CERTIFICATE OF OCCUPANCY  
THE CITY OF NAPOLEON

Re: 642 Briarheath Avenue not Briarheath Blvd.

Please find enclosed a marked up set of your proposed construction plans. Before we issue your building permits, it will be necessary to make corrections and incorporate them into the subject plans and provide the additional information requested. Once corrections are made you will need to submit two (2) full sets to my office for final review.

# POURED CONCRETE WALL NOT TO SCALE

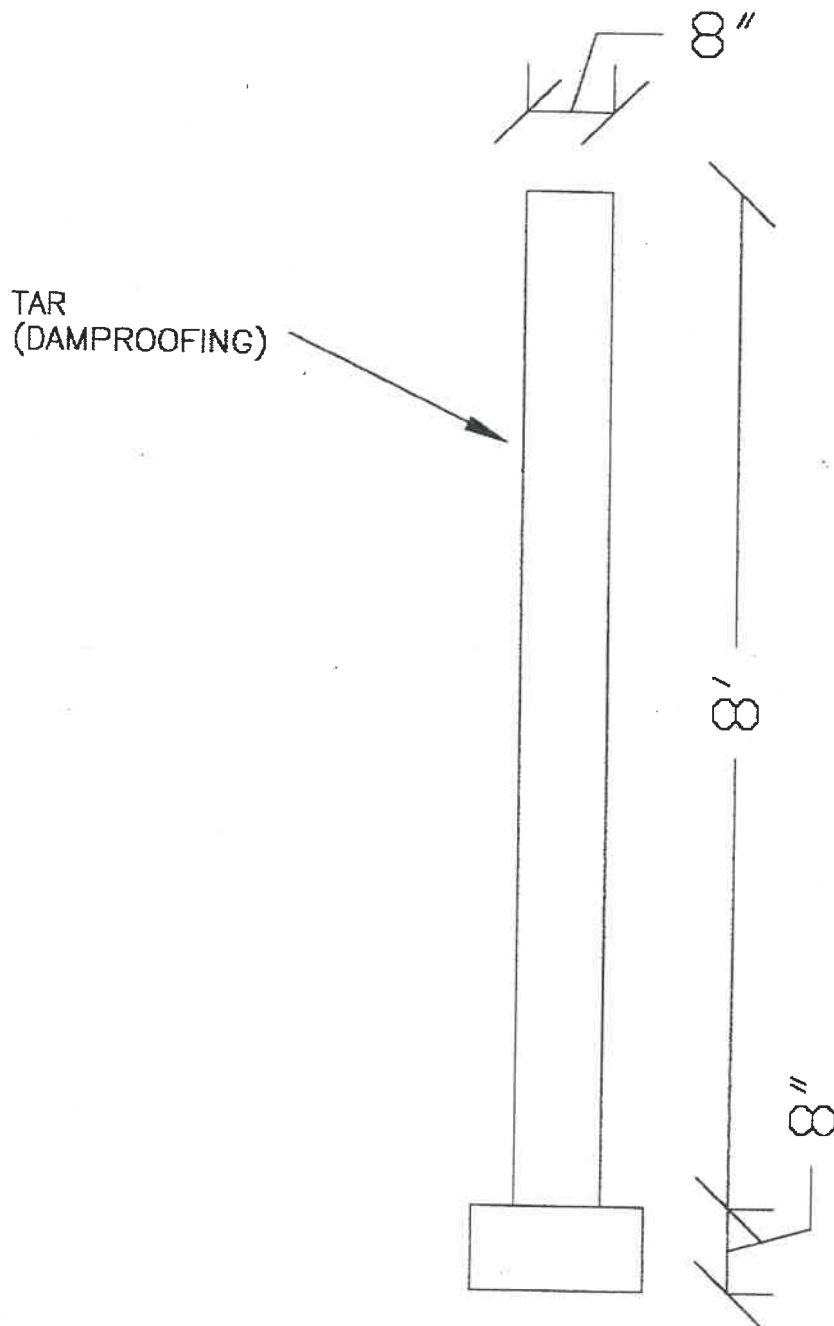
The poured in place concrete foundation walls must be shown within the plan sheets. Foundation reinforcement rod indicated by markups must be incorporated into the footings and walls unless you submit an alternate design stamped by state of Ohio engineer along with soil tests proving adequacy of such alternate design. I have also enclosed the approved lot drainage plan, compliance is required.
